**City of Bellevue  
Development Services Department  
Land Use Staff Report**

**Proposal Name:** Gardner Voluntary Compliance

**Proposal Description:** Critical Areas Land Use Permit to remove and reconstruct wall systems and other landscape features installed without permits on steep slope critical areas.

**File Number:** 16-130929-LO

Figure 1

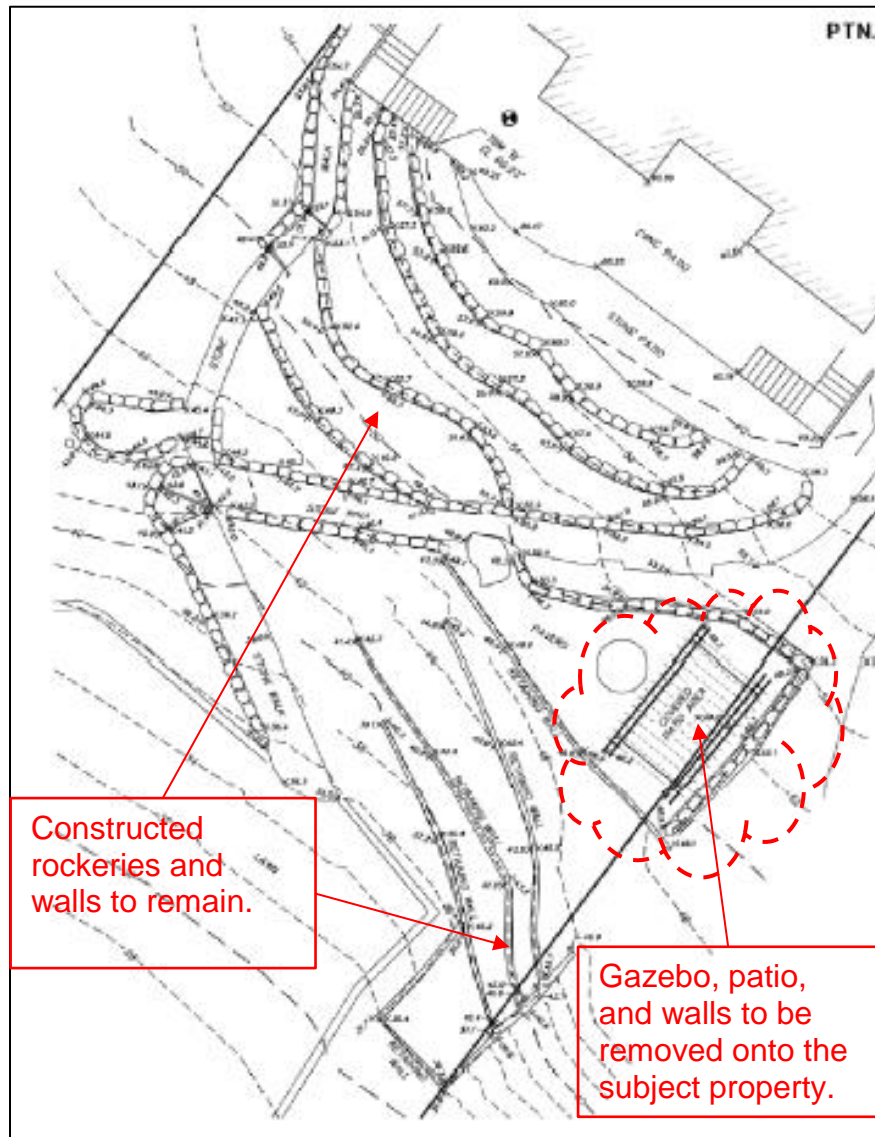
The applicant is requesting a Critical Areas Land Use Permit in order to obtain approval for stabilization work done without a permit that included construction of terraced rockeries, retaining walls, and landscaping improvements on a steep slope critical area that has been used and maintained for landscaping, paths, and other features. This application is required to permit work that proceeded without a permit and includes removal of a gazebo and improvements that do not conform to the City's codes. A portion of the constructed retaining walls is proposed to remain across the property line, with agreement from the adjacent property owner. See Figure 1 below for proposed improvements and photos of the improvements that were constructed without permits.
